ENVIRONMENTAL BOARD REGULAR MEETING MINUTES WEDNESDAY, October 15, 2008

a. Name: Wildflower Commons PUD C814-06-0233

SUBJECT:

Corrections to ERM's August 22, 2007 memo regarding Critical Environmental

Map 1: Location Map for Critical Environmental Feature Setbacks (Revised - 07-07-2008)

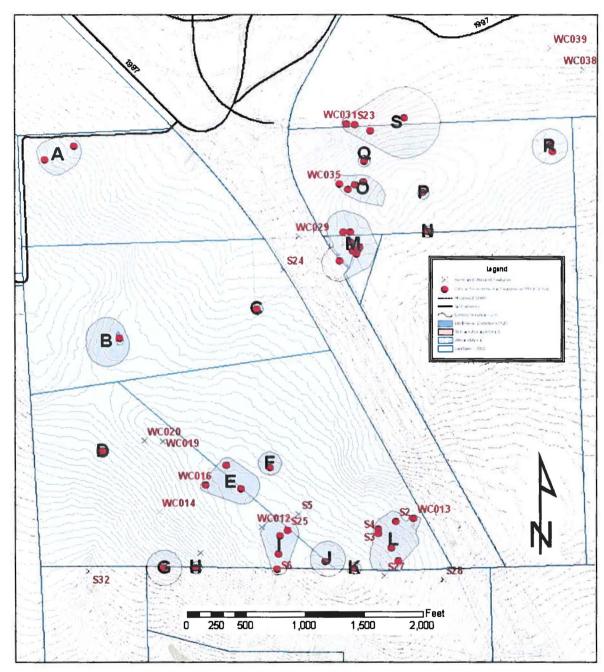
Based the surface drainage patterns, 2-ft topography, the type of feature, the feature's size and the density (or clustering) of features, ERM staff is recommending protecting the critical environmental features with 19 critical environmental feature setback areas (Labeled A thru S). The attached map shows the location of the setback areas. ERM staff is recommending that the CEFs and their associated setback area (or buffers) are documented within the PUD ordinance along with the following Land Development Code (LDC) requirements from Section 25-8-281.

- 1. No residential lots may include a CEF or be located within 50 feet of a CEF.
- 2. Setback areas must be established to protect all CEFs. Although the LDC allows a portion of the CEF buffer to be included in a residential lot, I do not recommend that this be allowed. Residential lots should not include any portion of a CEF buffer. Setbacks must comply with the setback area has stated in Table 1 and shown Map 1. ERM is willing to revise setback areas listed in Table 1 and shown on Map 1 during PUD process, if the applicant provides more detail information to ERM staff such has 1-ft topographic survey that better delineates the catchment areas and a hydrogeologic assessment the features that better evaluates it recharge potential.

- 1. All CEFs must be shown on a topographic map (or maps), and listed in a summary table and included on an exhibit (s) in the PUD ordinance. The table must include the identification of the CEF, the type of CEF, and the recommended setback area. All maps must be must have north arrow and reference scale.
